ADDENDUM No. 1

ITB No. 4706

WWTP HEADWORKS IMPROVEMENT PROJECT

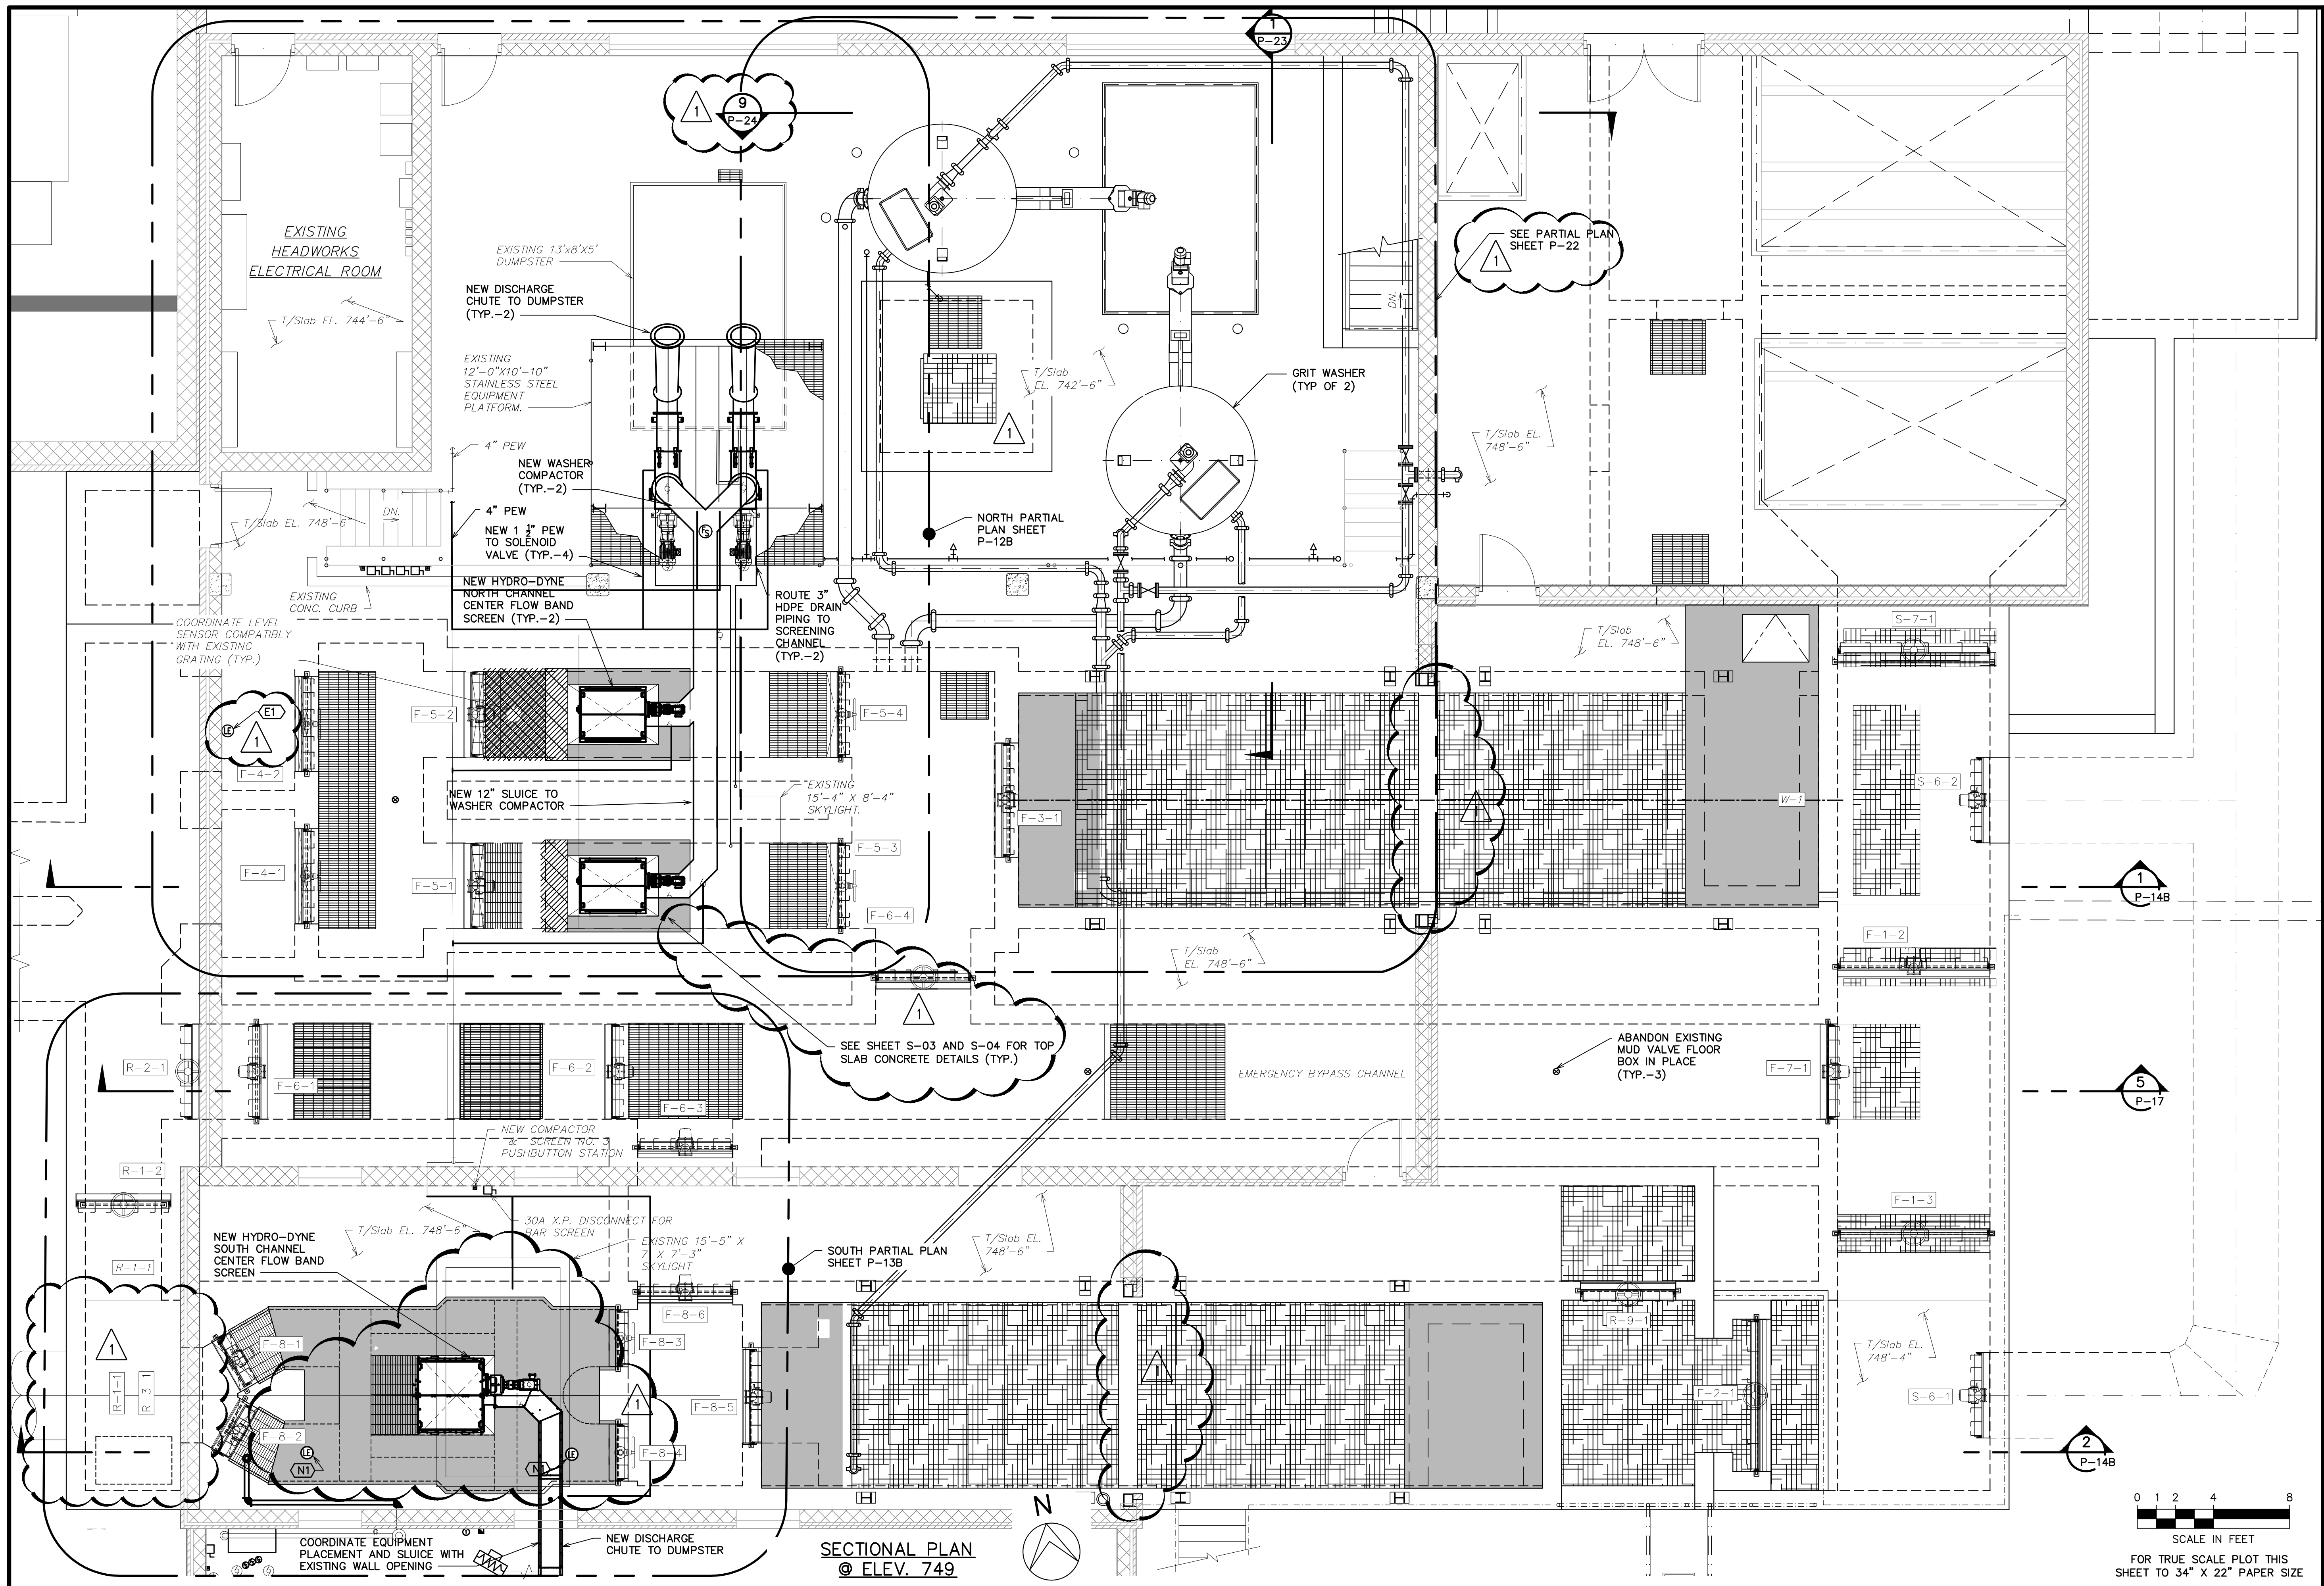
Question 12: Refer to plan sheets P-10A, near the top of the page is a section line indicating section 7 on sheet P-24. There is not a section 7 on sheet P-24, please clarify.

Question 13: Refer to plan sheets P-10A, in the upper right-hand quadrant of the page is a plan note which reads: "SEE PARTIAL PLAN SHEET P-25". There is not a sheet P-25 in the drawing set, please clarify.

Question 14: Refer to plan sheets P-10A/B, P-11A/B, P18, & P-19. The grit pipe at CL EL 756'-6" on sheets P-18 & P-19 does not fully appear in plan view on sheet P-10A. Please show the complete routing in plan view so that an accurate quantity of pipe and fittings can be included in the bid.

Answer 12: The section call out was intended to reference section 9 on sheet P-24. This reference has been changed to indicate the correct section.

Answer 13: This plan sheet reference was intended to reference the partial plan on sheet P-22. This reference has been changed to indicate the correct sheet.

Answer 14: Grit piping route provided on sheet P-10A and P-10B. Also note the grit piping shown on sheet P-11 A and P-11B.

SCALE 1/4" = 1'-0"
DRAWING NO. 716
SHEET NO. E-07

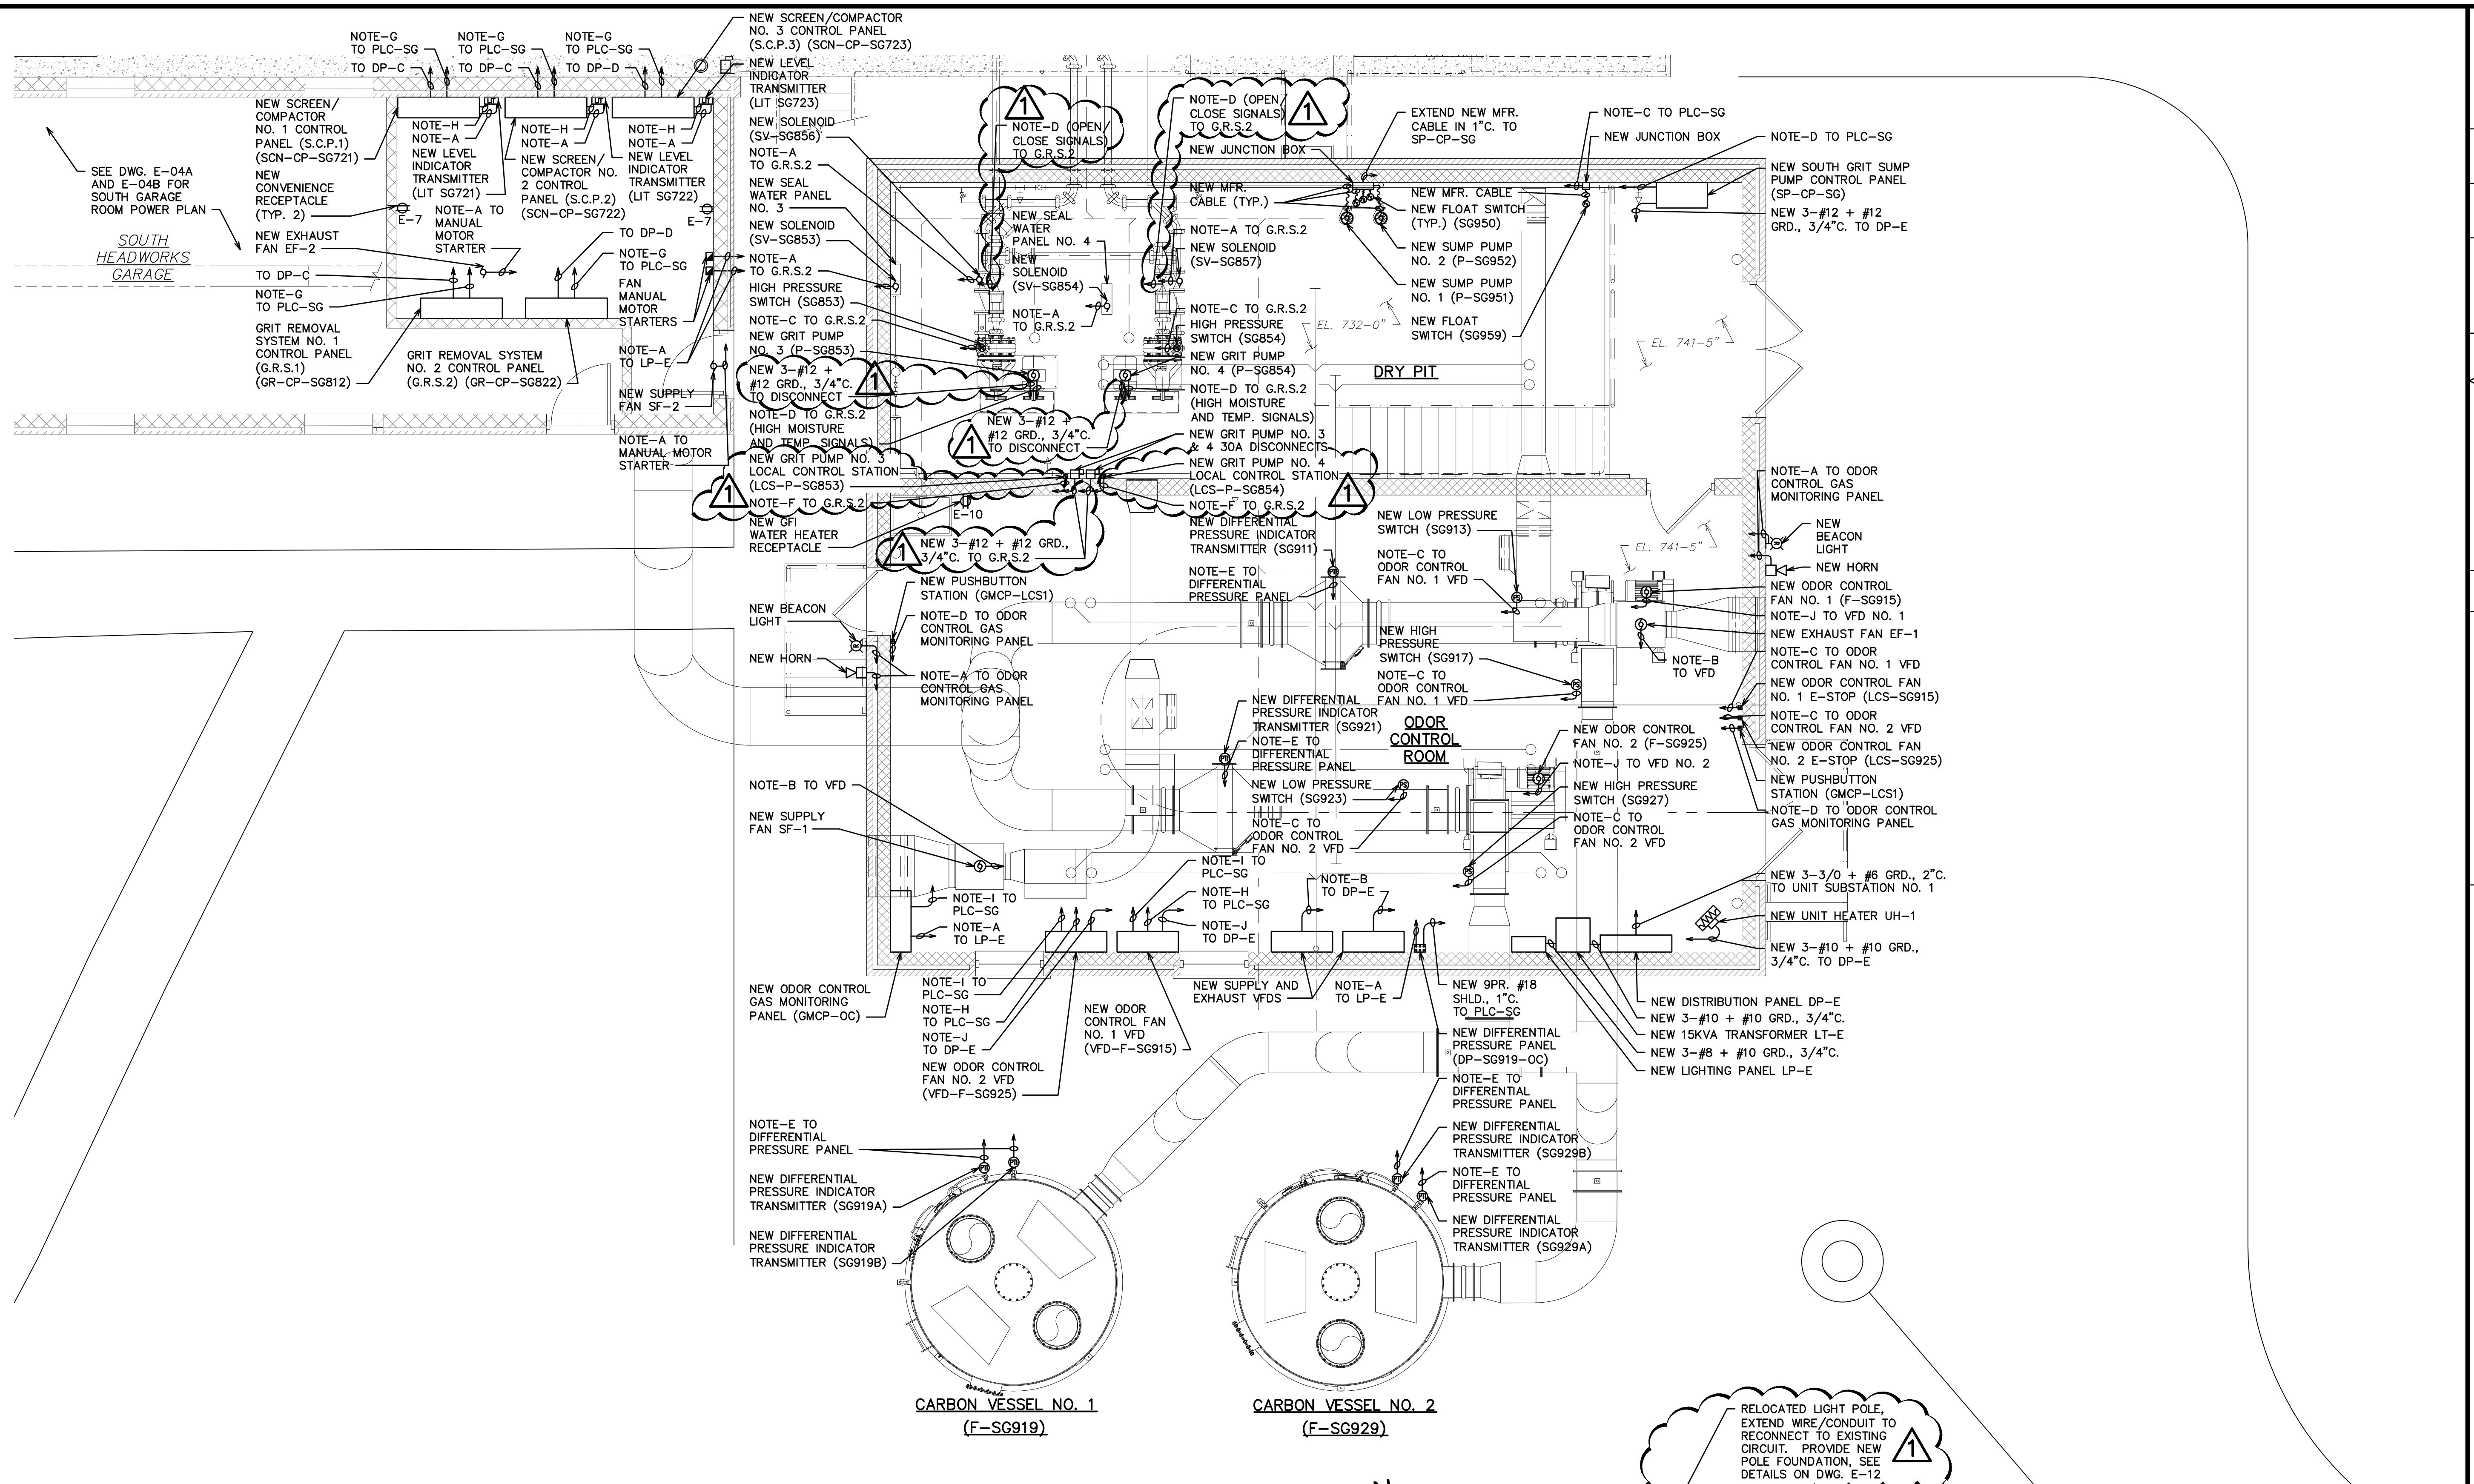
Question 34: Reference sheet E-07. There is a note that states all equipment inside the Odor Control Building/Dry Pit needs to be rated Class 1 Division 1 except in the electrical room. The drawing shows multiple VFD's along with a heater, GFI, disconnects, panels, DP-E, LT-E, and LP-E located in the operating area. Please clarify what (if any) of this equipment need to be rated Class 1 Division 1.
